RE: *St Leonards South – SU5945: Submission to Lane Cove’s St Leonards South Residential Precinct Draft Plans*

Submission: St Leonards and Crows Nest 2036 Plan

Figure 2 Proposed building envelopes
Source: Kann Finch Architects

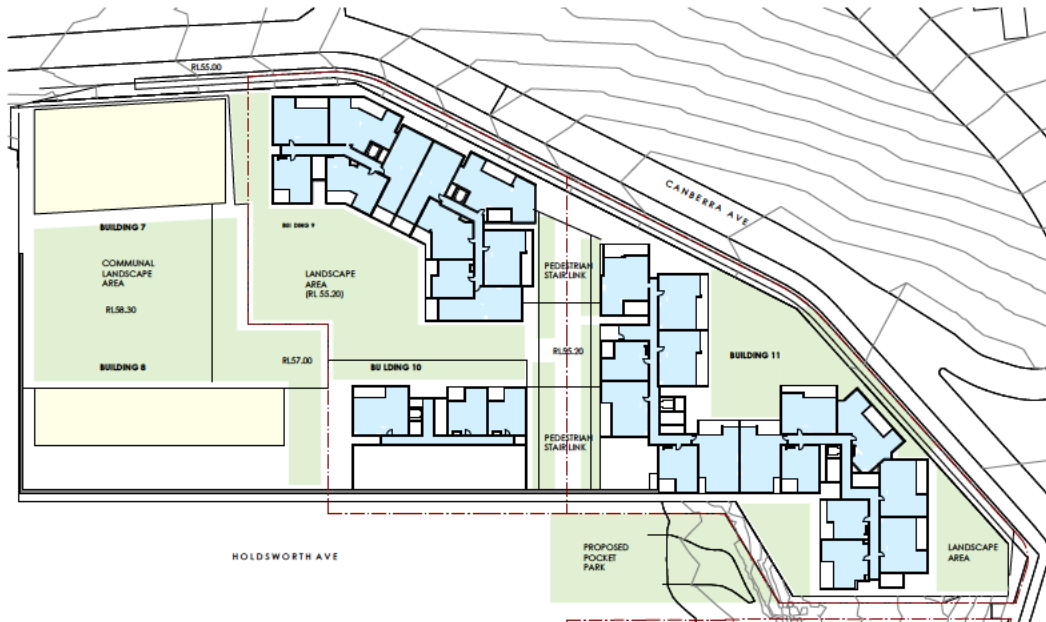
However, based on these concepts we suggest the following suggestions be implemented (refer to Figure 2 below):

- To better mediate the level difference between Holdsworth and Canberra Avenues along the pedestrian through-site link to the northern edge of Lot 11, we recommend that the mid landing be at approximately RL 55.0. rather than RL58.0;
- That the body of the proposed landscaped spine running between Lots 9 and 10 be at RL 55.0. rather than RL61.0. This will allow for a direct level connection from Canberra Avenue into the proposed landscaped spine;
- That in certain circumstances, basement parking is permitted below 'deep soil' areas, where the soil depth can be at least 1.1m deep. This will permit greater flexibility to deliver functional basements, while still enabling essential mature trees and vegetation to flourish; and

- That flexibility be provided with respect to removal of existing mature trees (10m or more tall) as noted in Figure 8.22. We suggest that where these trees currently stand in Central Areas that may require cut and fill/benching to address level changes to achieve useable outdoor communal spaces, a flexible approach is taken, including the possibility of vegetation 'offsets'.

Figure 2 Satellite image of the existing Newlands Park

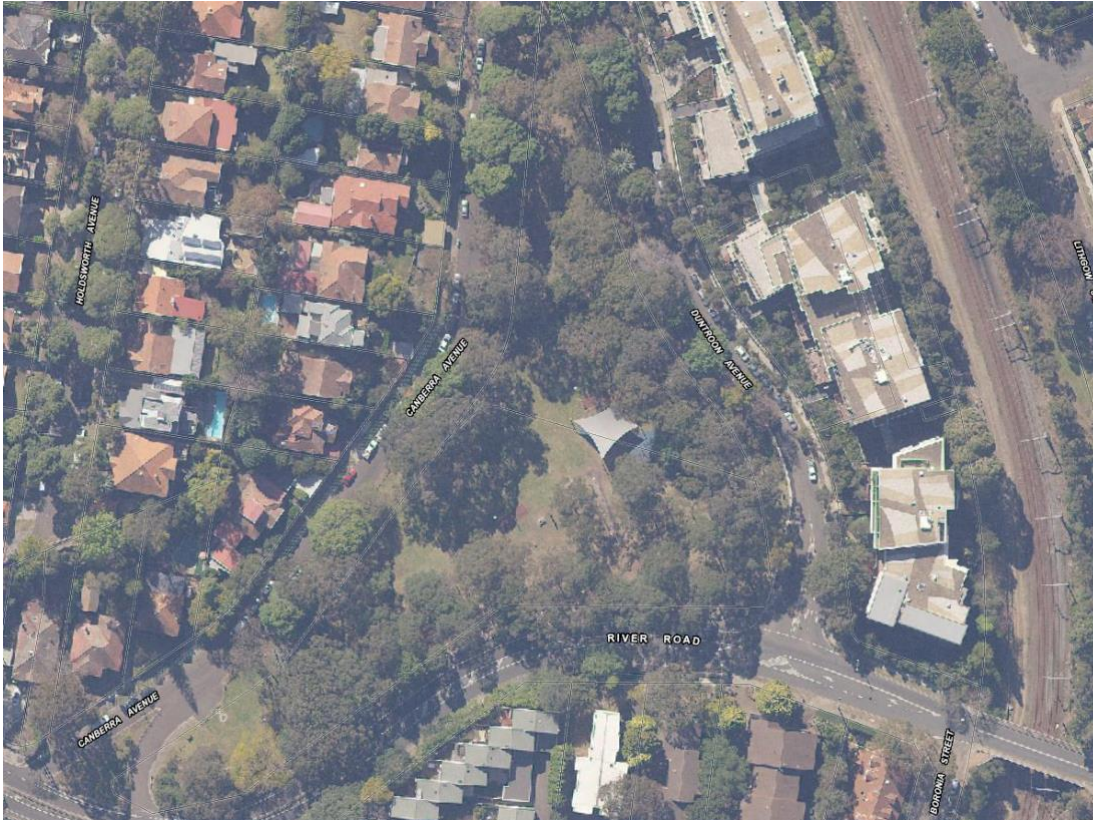
- It is important to acknowledge in our climate, that shading from direct sun is often needed throughout the year to maximise amenity. Newlands Park currently has playground equipment with shade structures above (refer to Figure 2 below), as direct exposure to sunlight onto children and families utilising the park can cause health and safety issues; and
